Re: **Technical Response for the Raging River Quarry (Parcel # 222407-9011):
Clearing & Grading Permit # GRDE15-0004 King County, WA.**

Per your request this letter is written as response to an additional County review comment that was addressed in the last Technical Response (Comment/Response #4, 8/1/17 Letter - Technical Response for the Raging River Quarry (Parcel # 222407-9011) Clearing & Grading Permit # GRDE15-0004 King County, Schulz). However, some new information regarding the presence of wetlands within ½ mile of Wetland A was provided by Laura Casey (King County Environmental Scientist III) via email on March 20, 2018. Also included in the email is an explanation that the connections between the Quarry wetlands and the off-site wetlands are "Relatively undisturbed". The determination of wetland connections being "Relatively undisturbed" is the focus of this response letter as it would change the wetland rating Habitat score and wetland buffer for Wetland A.

Regular & Frequent Disturbance Map

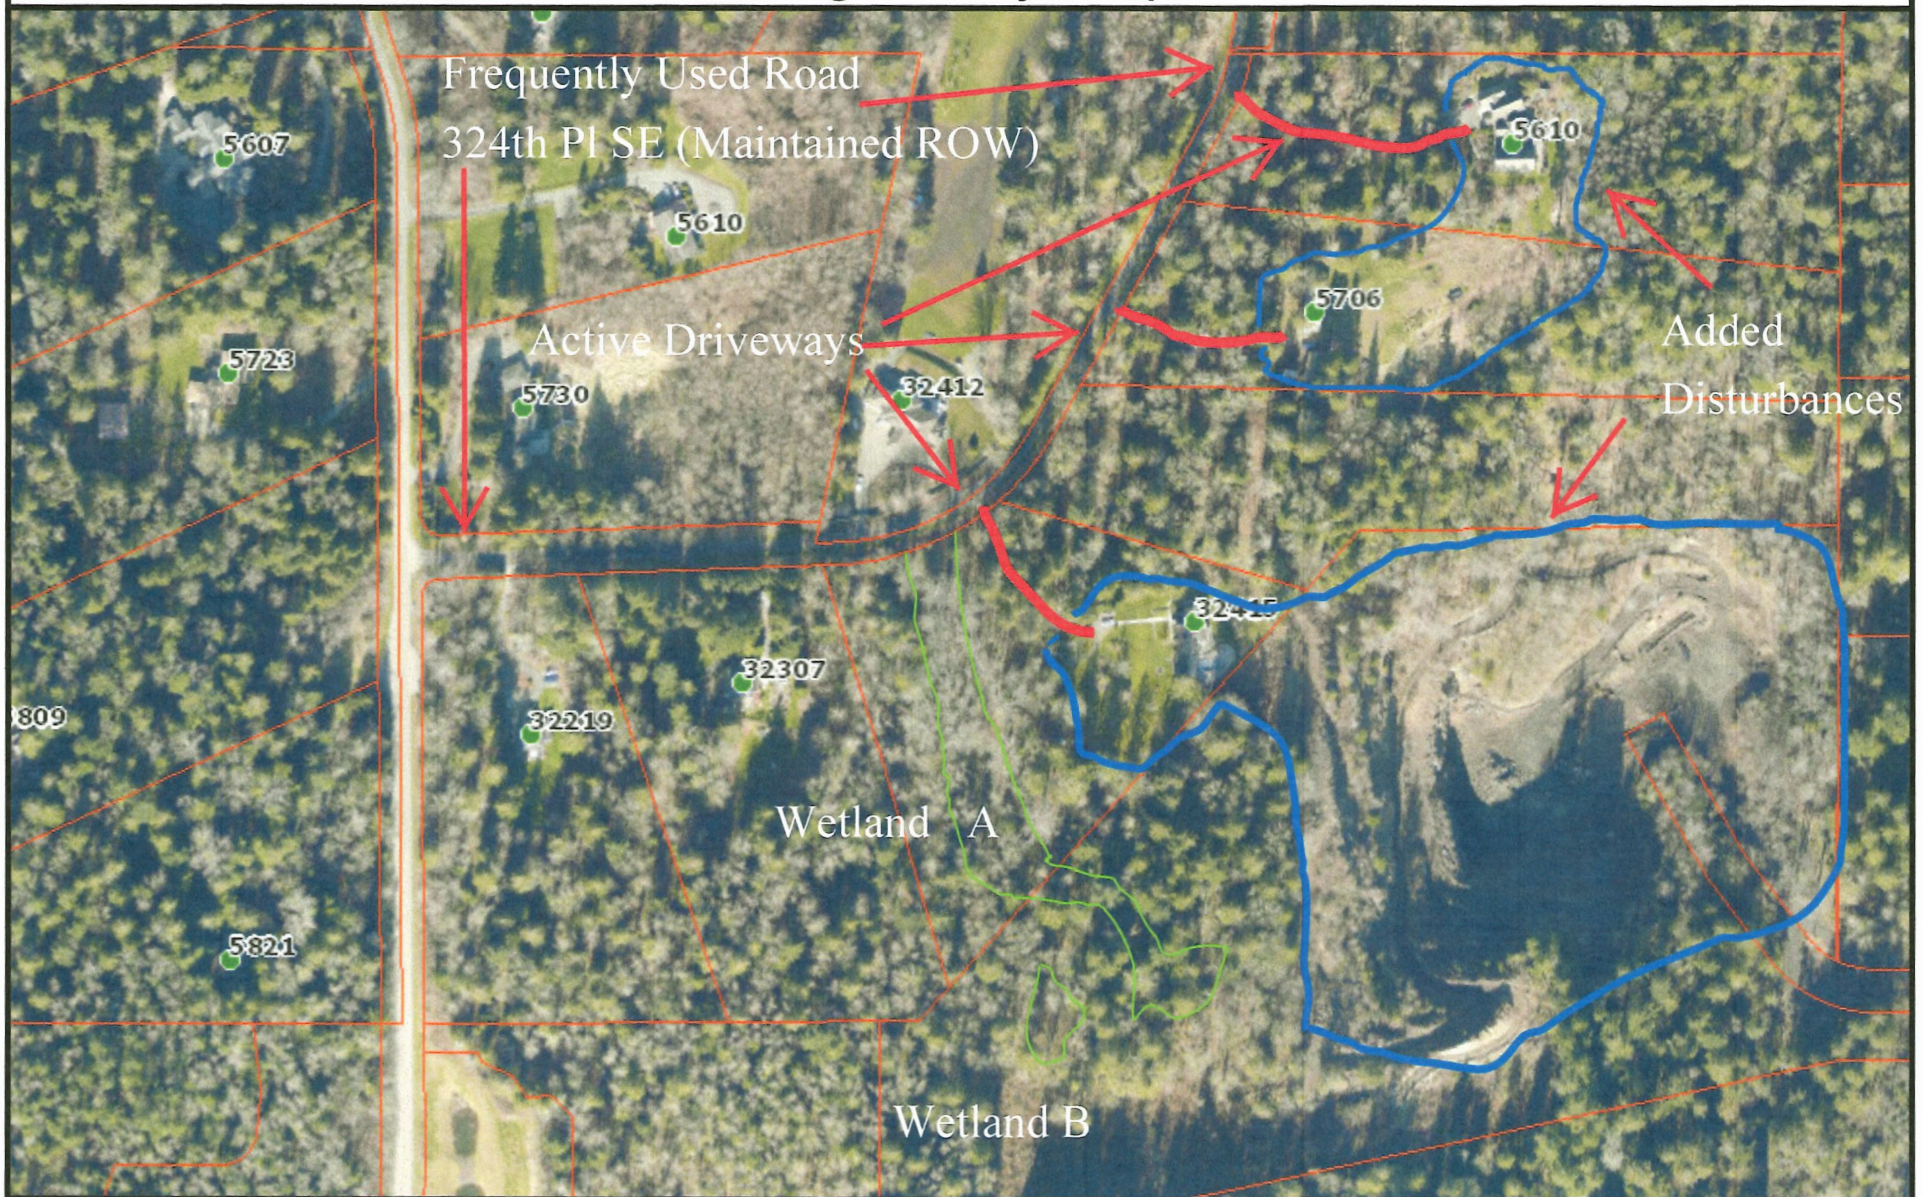
The attached Disturbance Map is used as the aerial photograph that depicts current activities and conditions from past clearing of native forest. The habitat connections between Wetland A and the wetlands located to the north have some natural forest cover but are largely disturbed from residential development. There are 3 frequently used gravel driveways between the wetlands. In addition the proximity of the 324th Pl. SE gravel road ROW used to access the local residential properties and the existing Quarry would be considered regular disturbances. Due to the gravel road ROW there is little if any functioning buffer habitat along wetland areas that are adjacent to the road.

The backyards or eastern portions of the lots located at 32415 SE 58th Street and 5706 324th Pl. SE are mowed and maintained. These disturbances would impact any connection between Wetland A and the small wetland shown on the old Notice on Title map for 5610 324th Pl. SE.
